NOTICE OF PUBLIC HEARING
ELMWOOD CHARTER TOWNSHIP
PLANNING COMMISSION

Re: Farm Club Site Plan Amendment

To: Elmwood Planning Commission
From: Sarah Clarren, Planner / Zoning Administrator
Date: 8/14/24
RE: SPR/SUP 2024-05, Farm Club Expansion (2)

PLANNING COMMISSION
FINDINGS OF FACT, DECISION AND ORDER
SPR/SUP 2024-05, Farm Club Expansion (2)

Farm Club
Farm Club
NOTES & DETAILS SHEET
Section 18, Town 28 North, Range 11 West
Elmwood Township, Leelanau County, Michigan

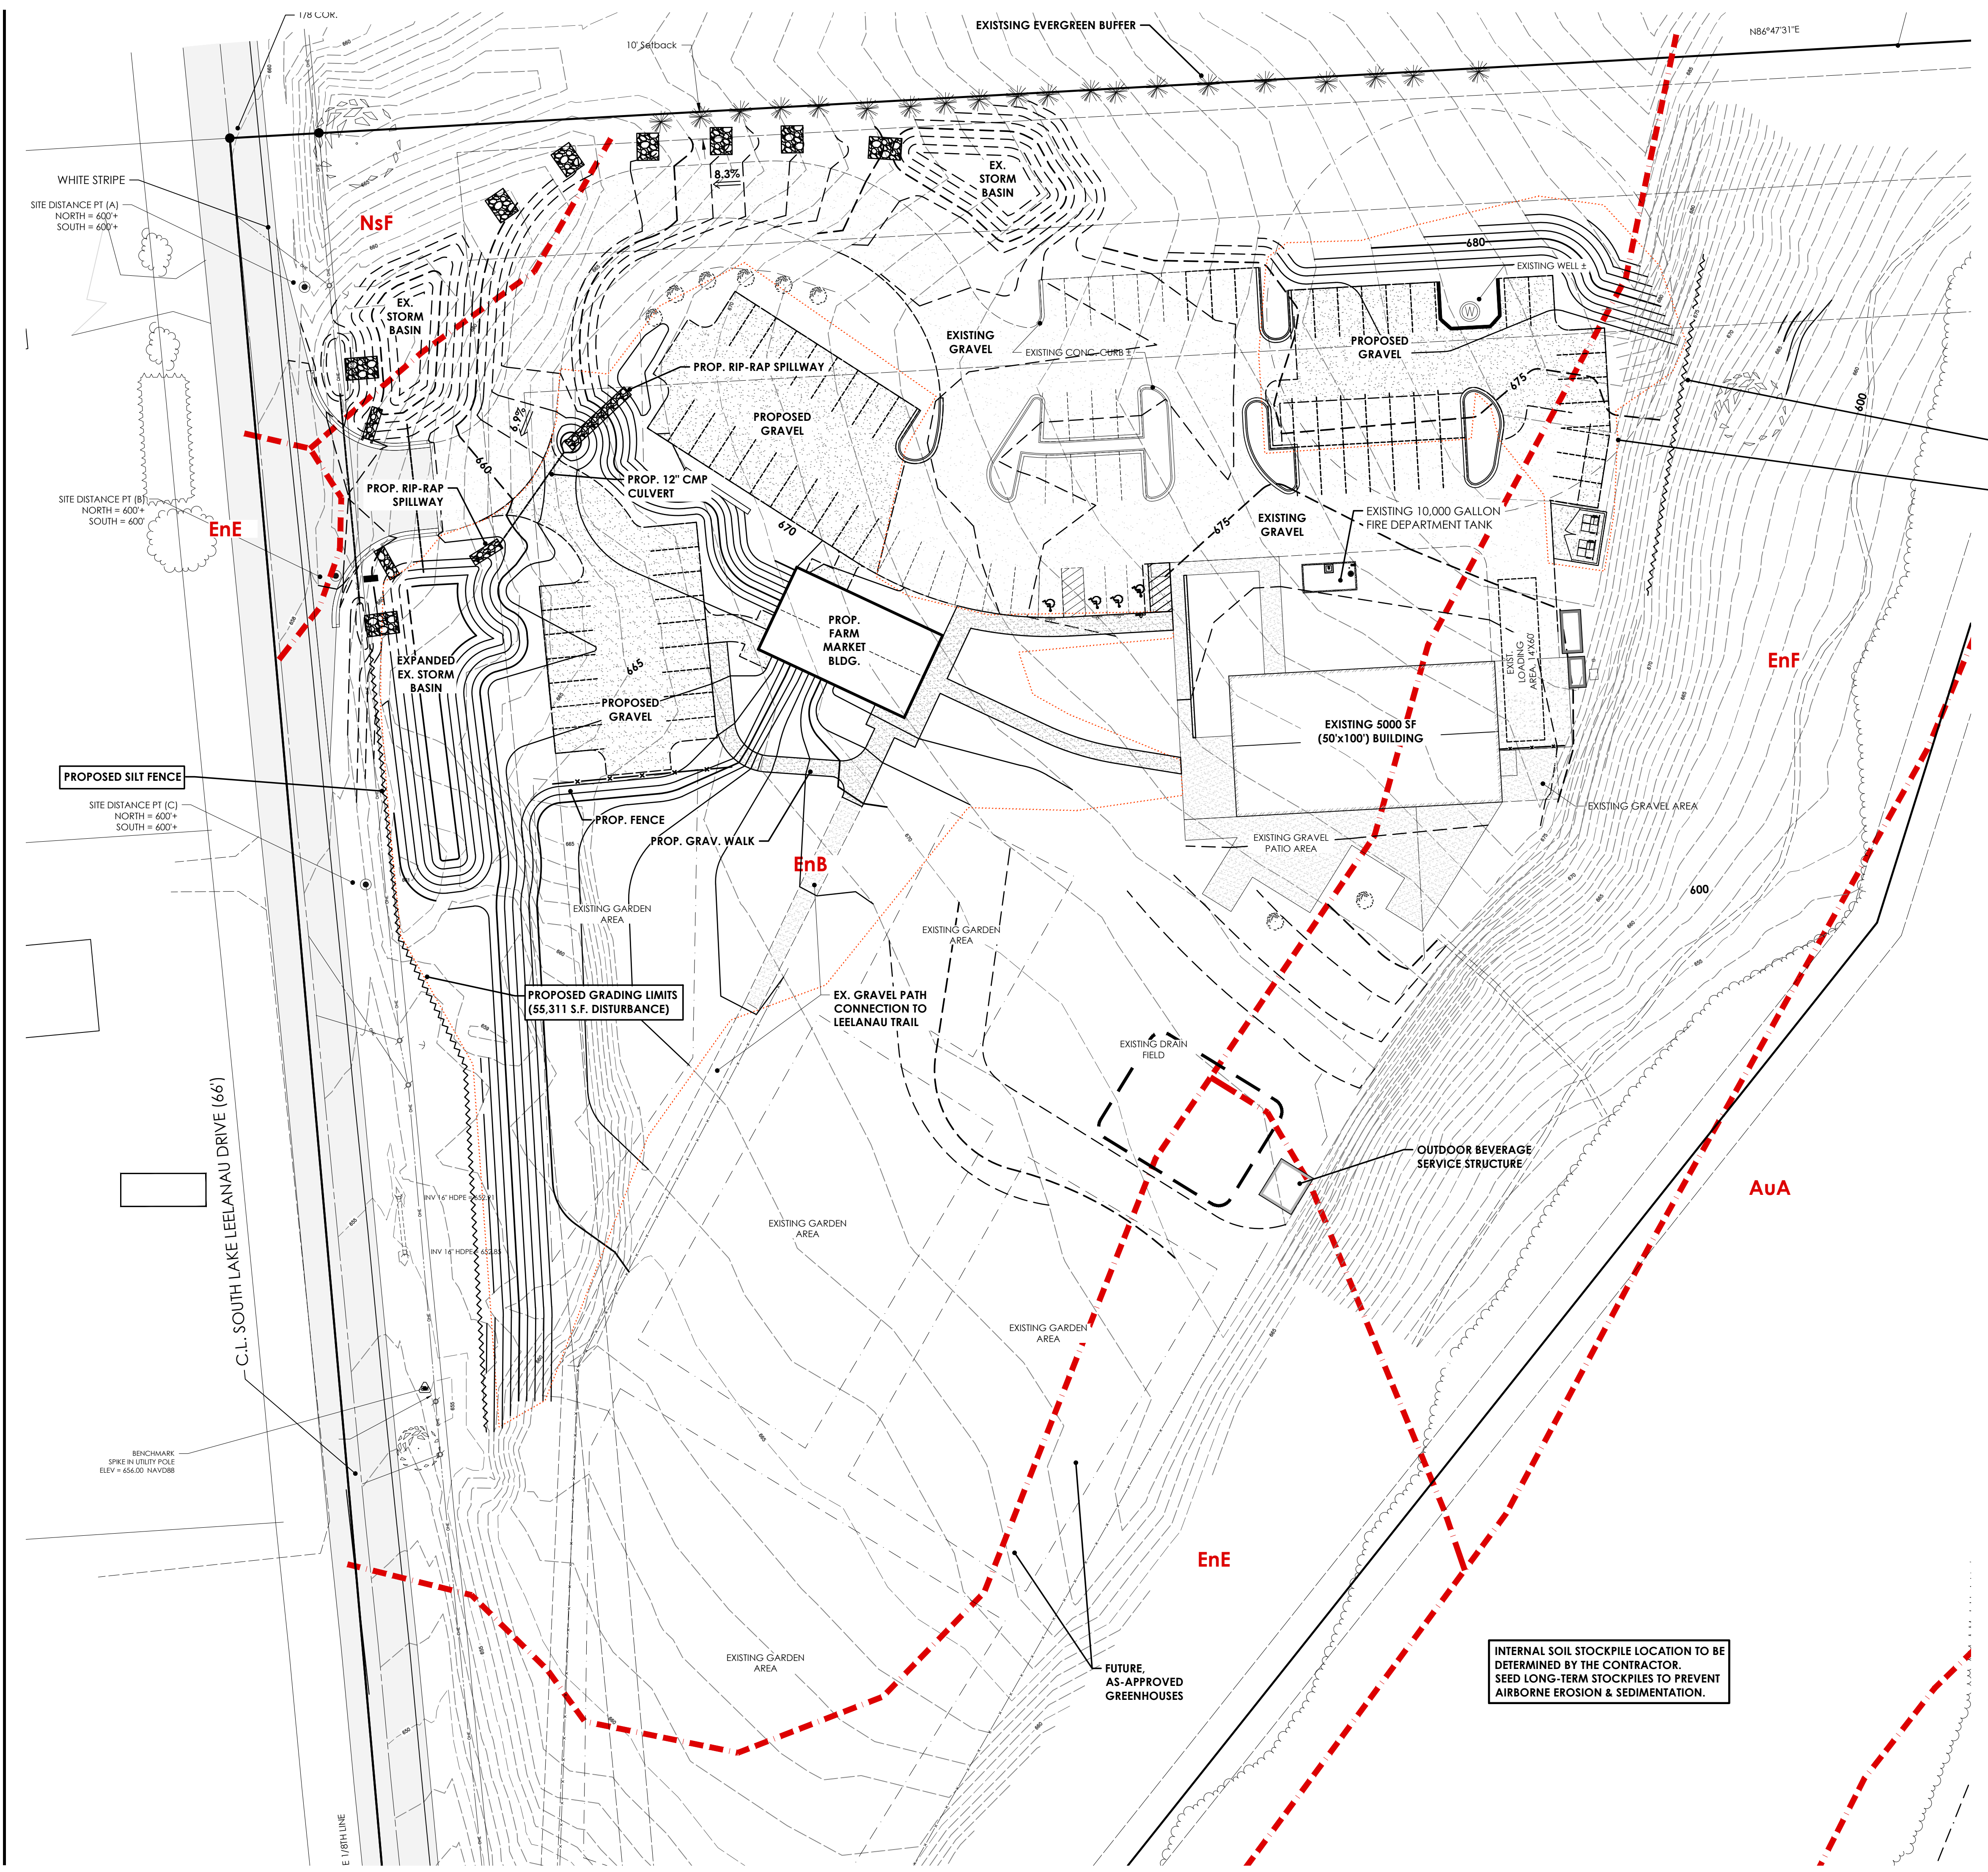
32. Location and specifications for all fences, walls, and other screening features, with cross sections shown. ***Location of vegetated buffer shown (L1.0), dumpster screening and planting detail (C1.1). Note that buffering on plan still does not meet the requirements of Section 6.4.3.A of the Ordinance. Can be made a condition of approval.***

Farm Club
Farm Club
SOIL EROSION & SEDIMENTATION CONTROL PLAN
Section 18, Town 28 North, Range 11 West
Elmwood Township, Leelanau County, Michigan

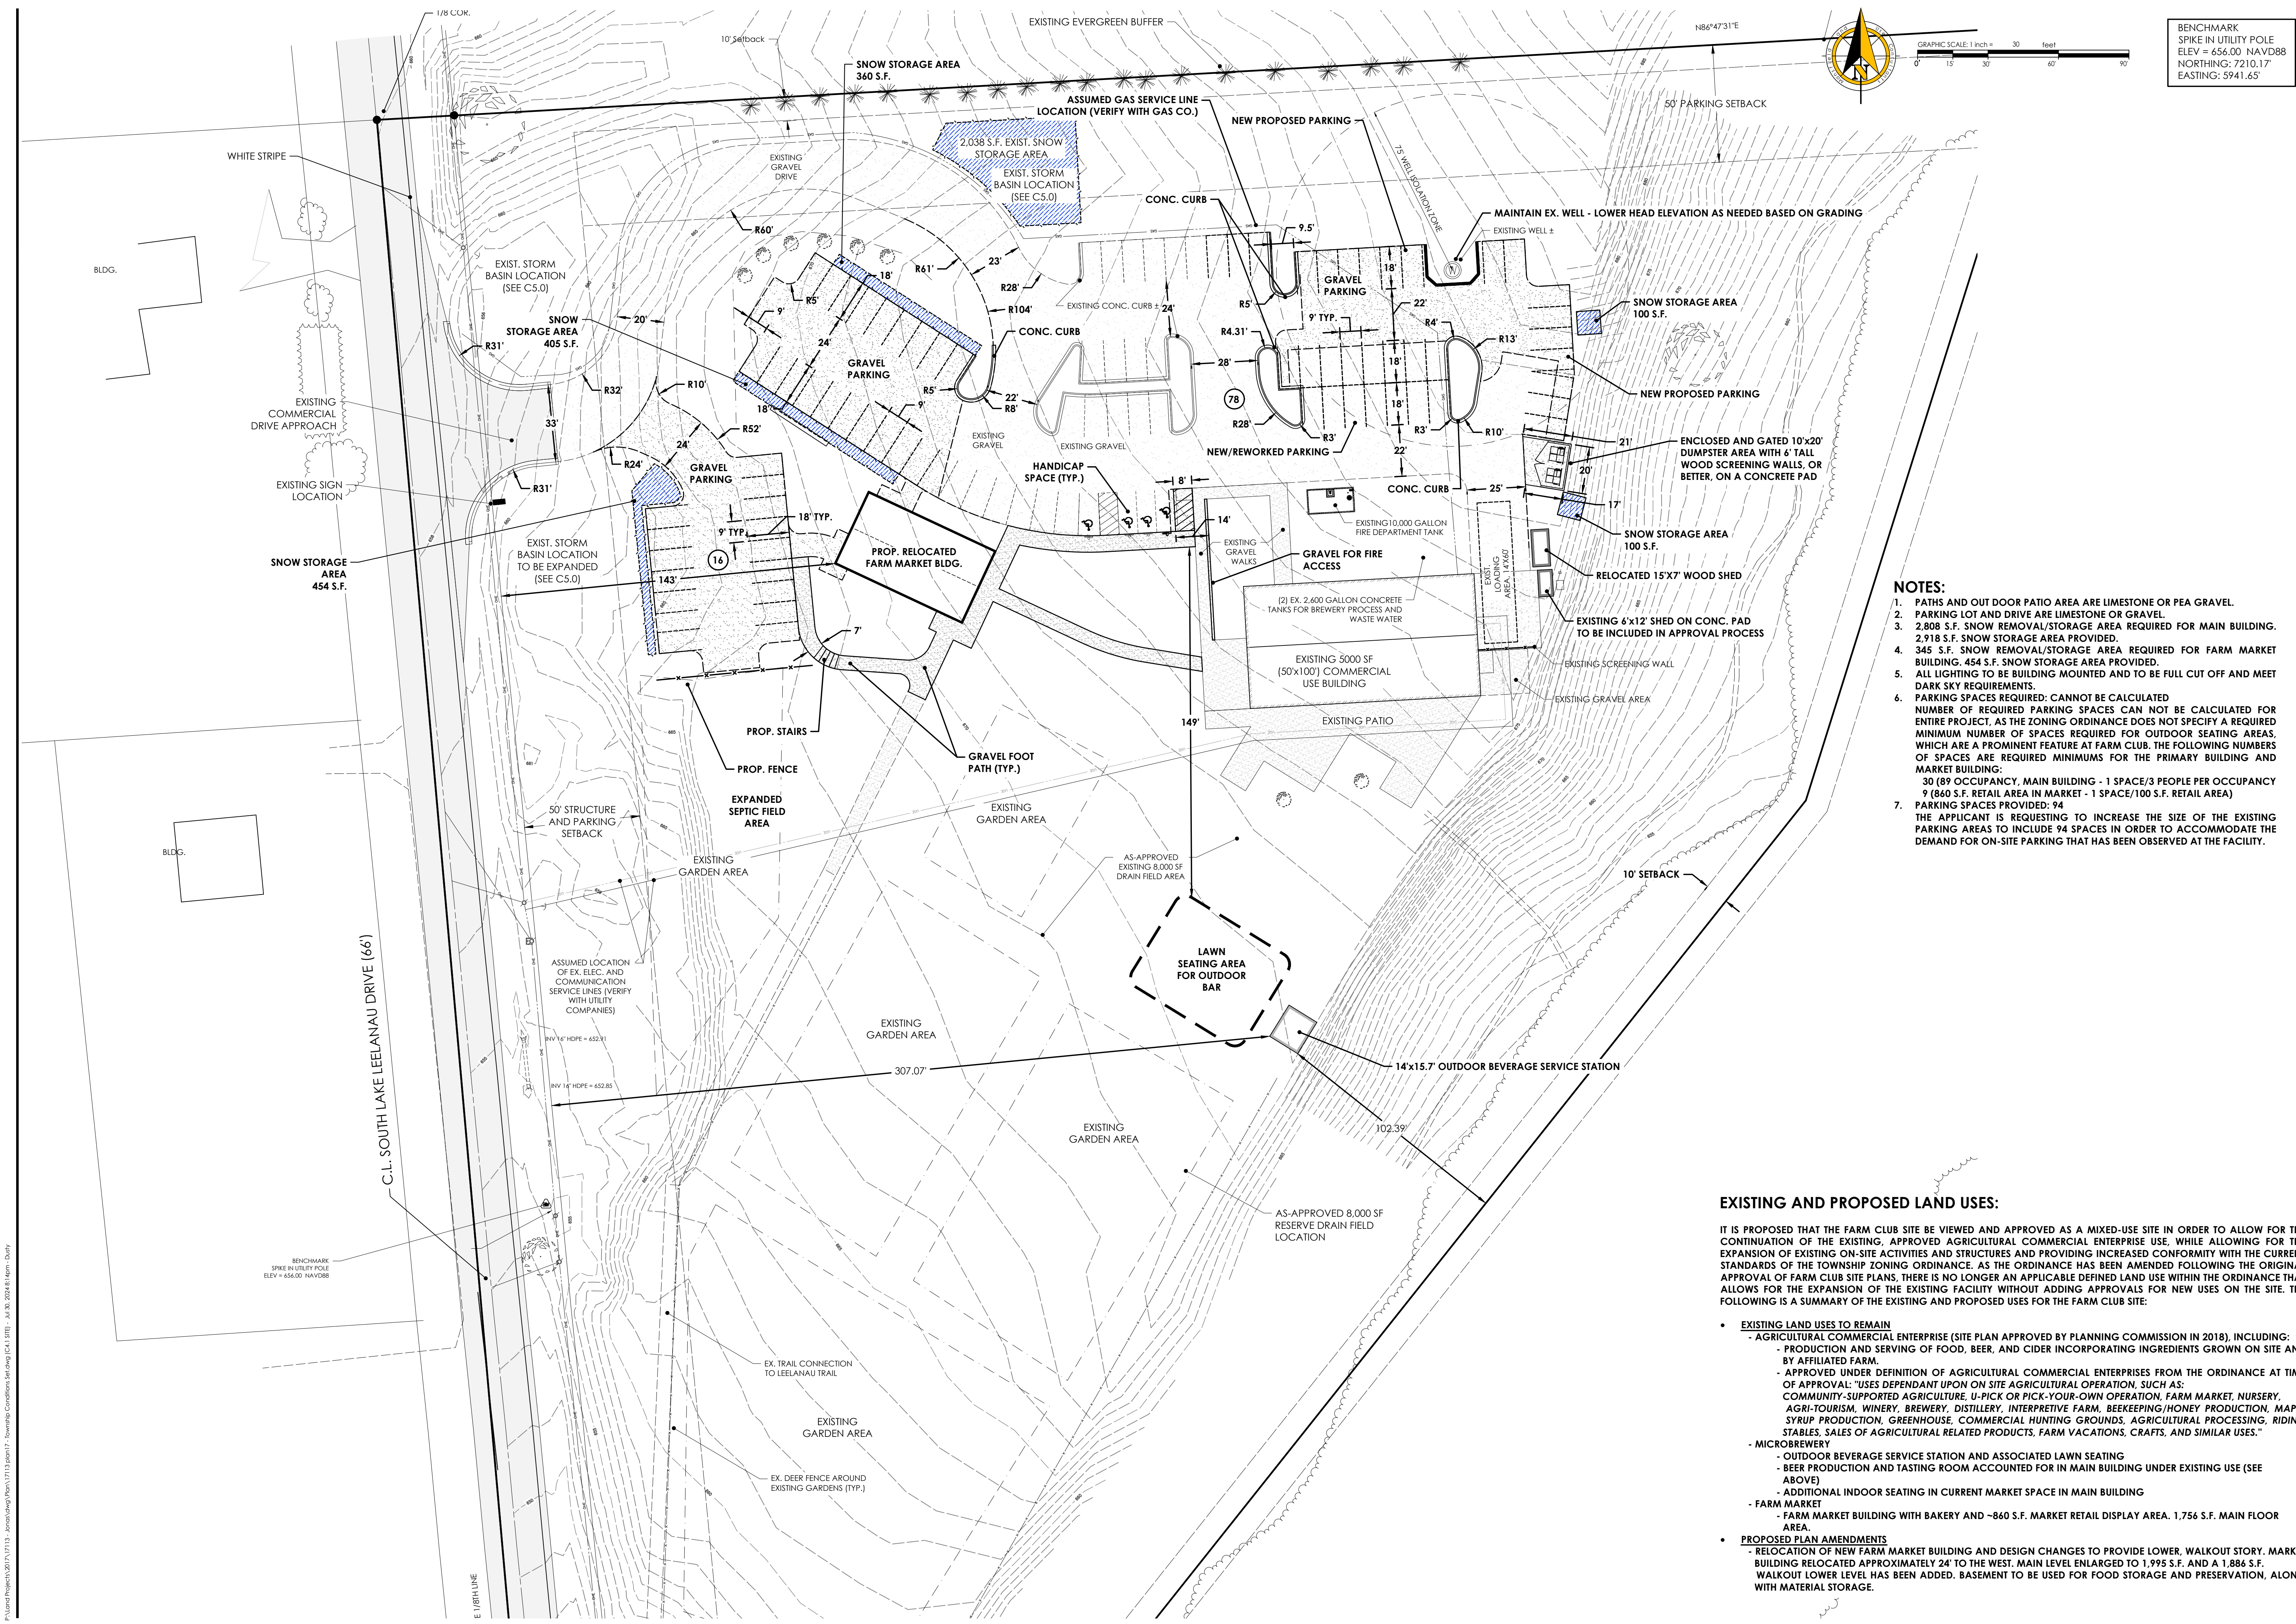
18. Location and elevations of existing water courses and water bodies, including county drains and man-made surface drainage ways, floodplains, wetlands, and sand dunes. *Provided (C3.0, C4.0 (wetlands approximate and don't show full extent, but does not appear to be on subject parcel (EGLE Wetlands Map View)).*

Farm Club
Farm Club
SITE AND DIMENSION PLAN
Section 18, Town 28 North, Range 11 West
Elmwood Township, Leelanau County, Michigan

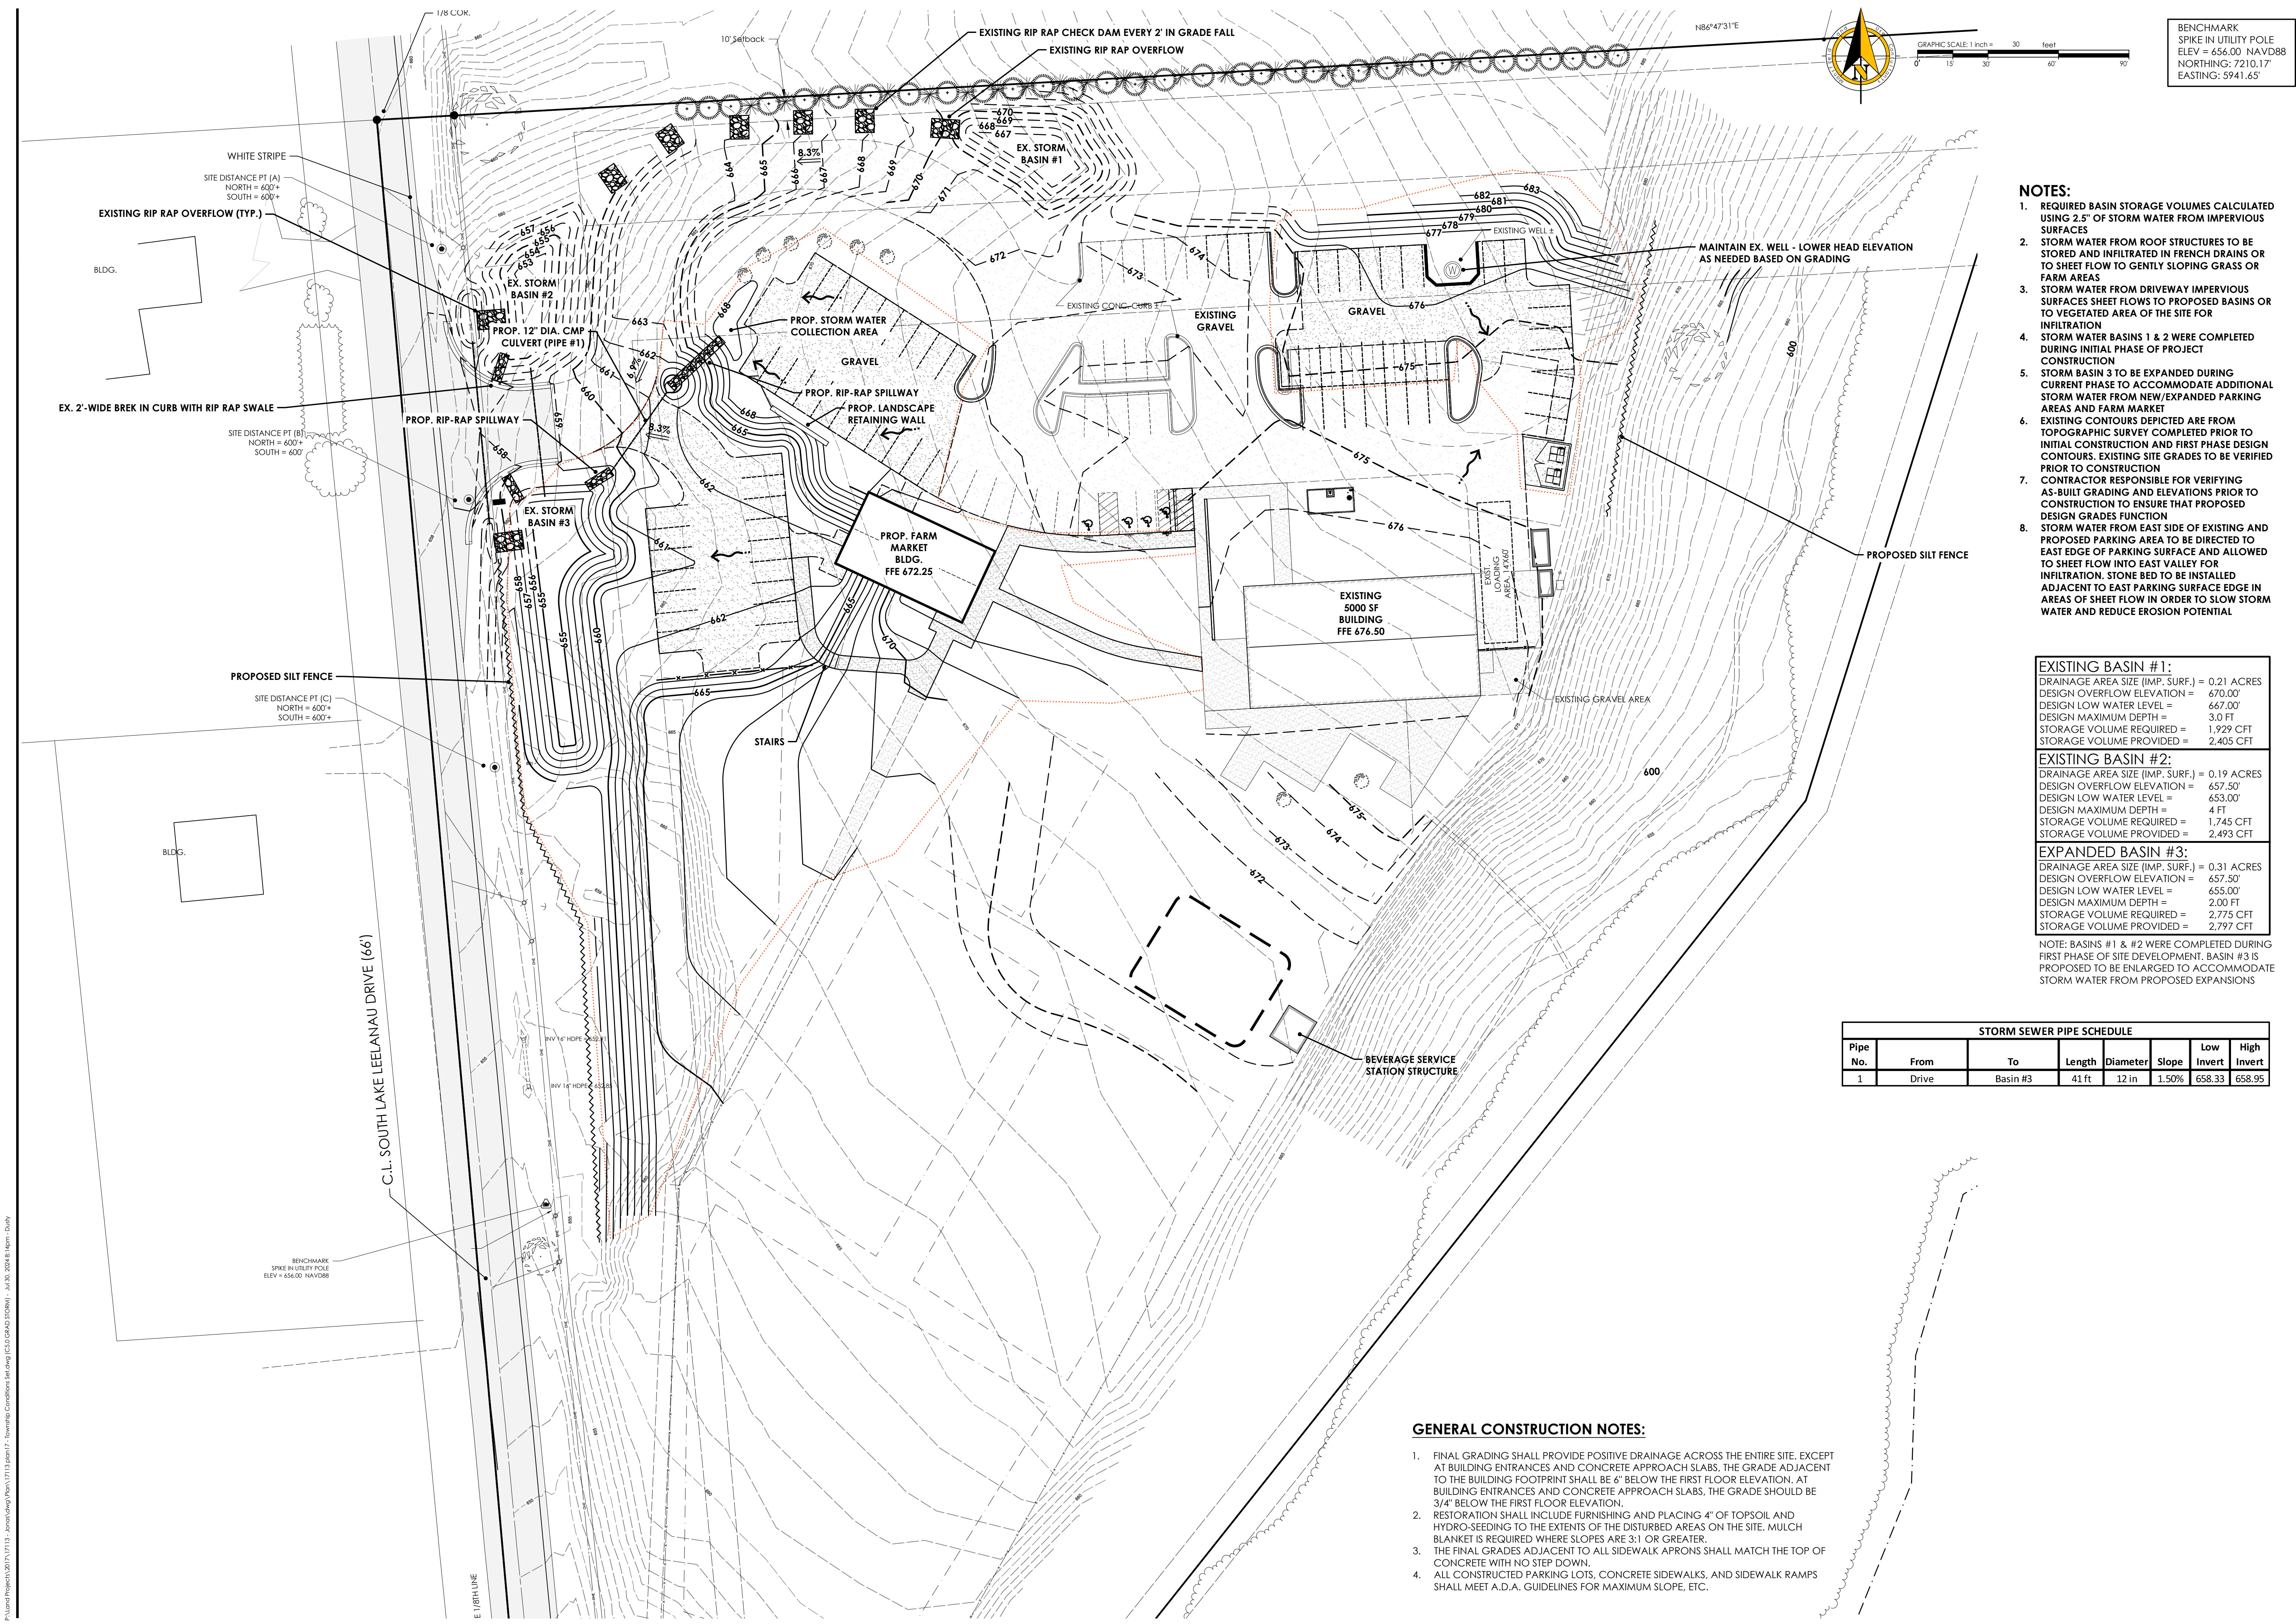
- E. The subject parcel is surrounded by parcels zoned A-R, but each abutting parcel has a residential use on it.
- F. Sheet C4.1 (last rev. 8/16/23) calls for 94 parking spaces and states “The Applicant is requesting to increase the size of the existing parking areas to include 94 spaces in order to accommodate the demand for on-site parking that has been observed at the facility.”
